Application for Variation of an Environmental Permit

Highways Department

C2. Application No. of the Current Environmental Permit : VEP-561/2019

Project Title: Central-Wanchai Bypass (CWB) Including Its Road Tunnel and Slip Roads
工程項目名稱: 中環灣仔繞道包括其行車隧道及連接路

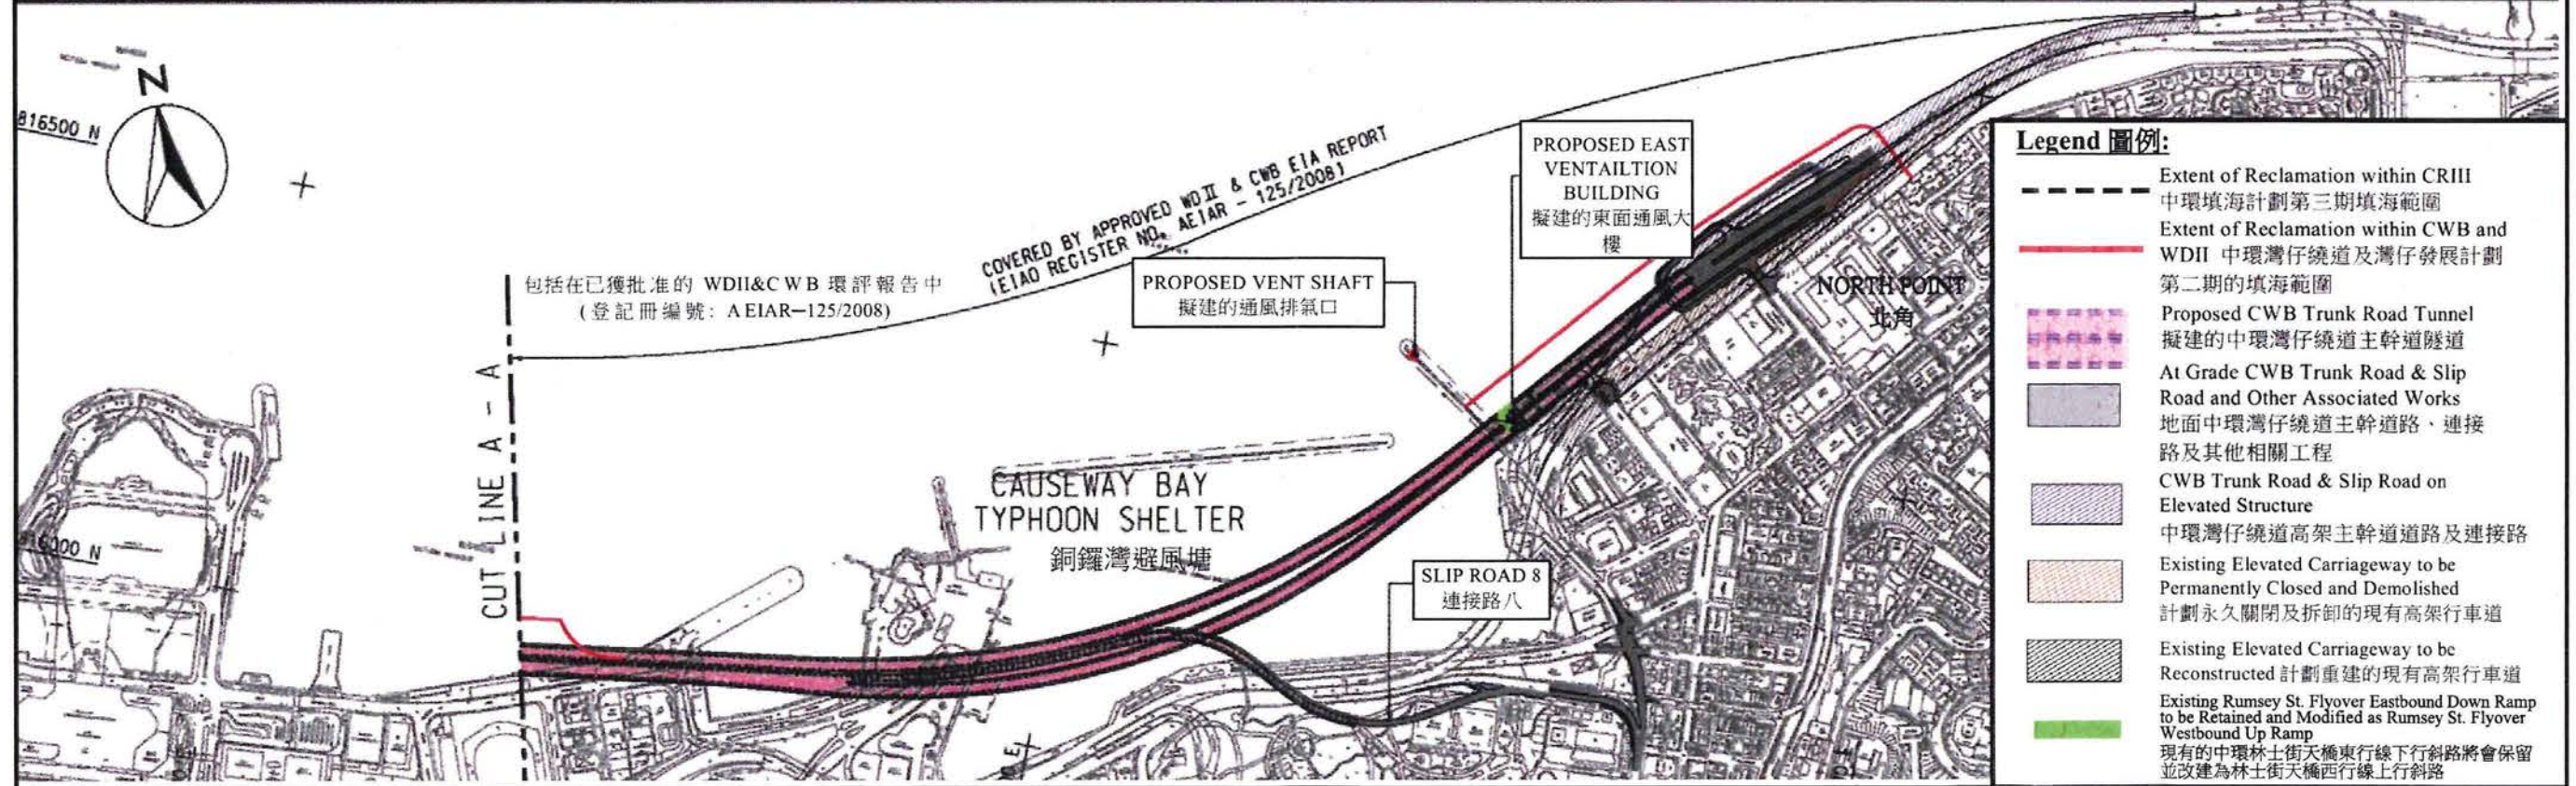
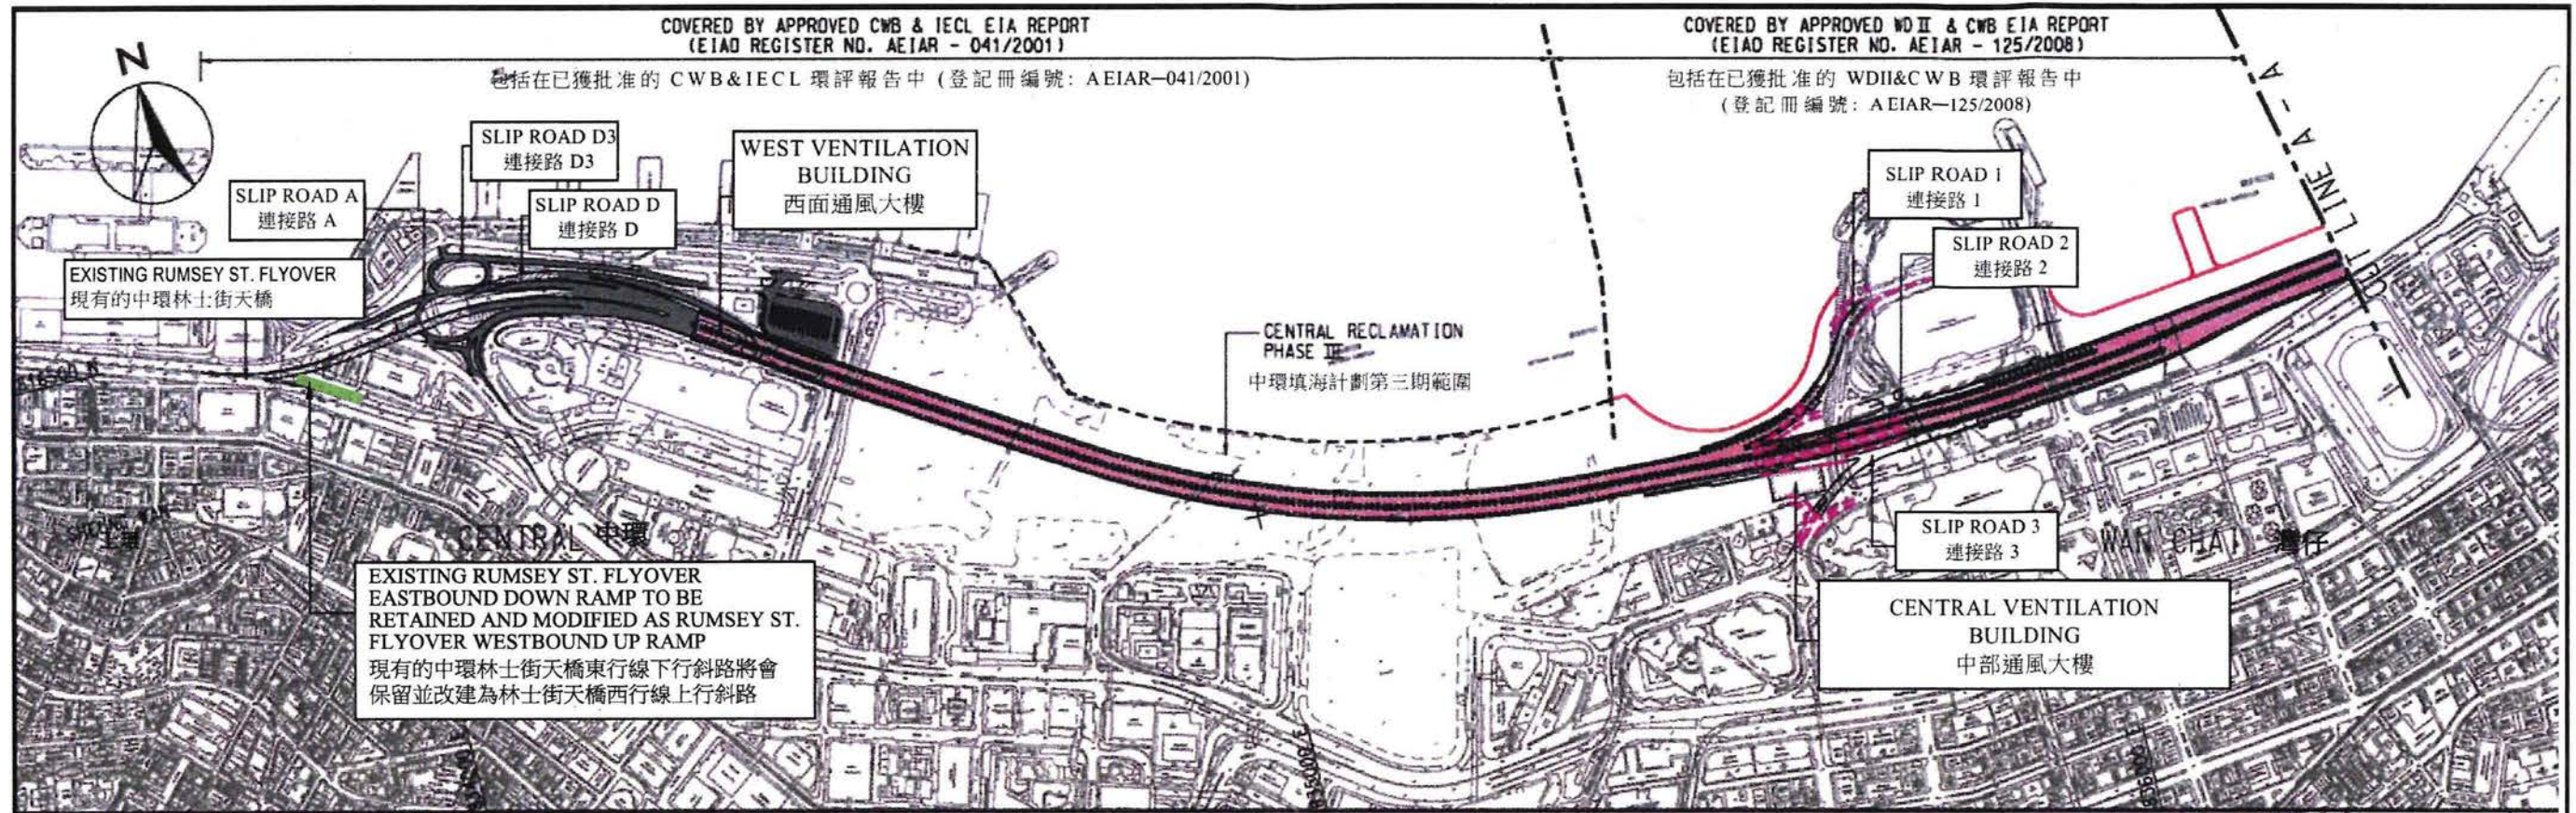
| D1. Condition(s) in the Current Environmental Permit : | D2. Proposed Variation(s) : | D3. Reason for Variation(s) : | D4. Describe the environmental changes arising from the proposed variation(s) : | D5. Describe how the environment and the community might be affected by the proposed variation(s) : | D6. Describe how and to what extent the environmental performance requirements set out in the EIA report previously approved or project profile previously submitted for this project may be affected : | D7. Describe any additional measures proposed to eliminate, reduce or control any adverse environmental impact arising from the proposed variation(s) and to meet the requirements in the Technical Memorandum on Environmental Impact Assessment Process : |
|--|---|---|---|---|--|--|
| Figure 1 Existing Rumsey St. Flyover Eastbound Down Ramp to be Permanently Closed and Demolished | Figure 1 Existing Rumsey St. Flyover Eastbound Down Ramp to be <u>Retained and Modified as Rumsey St. Flyover Westbound Up Ramp</u> | Please refer to the Section 1 of the attached Environmental Review Report for Retaining Rumsey Street Flyover Eastbound Down Ramp | Please refer to the Section 1 of the attached Environmental Review Report for Retaining Rumsey Street Flyover Eastbound Down Ramp | Please refer to the Section 1 of the attached Environmental Review Report for Retaining Rumsey Street Flyover Eastbound Down Ramp | Please refer to the Section 1 of the attached Environmental Review Report for Retaining Rumsey Street Flyover Eastbound Down Ramp | Please refer to the Section 1 of the attached Environmental Review Report for Retaining Rumsey Street Flyover Eastbound Down Ramp |
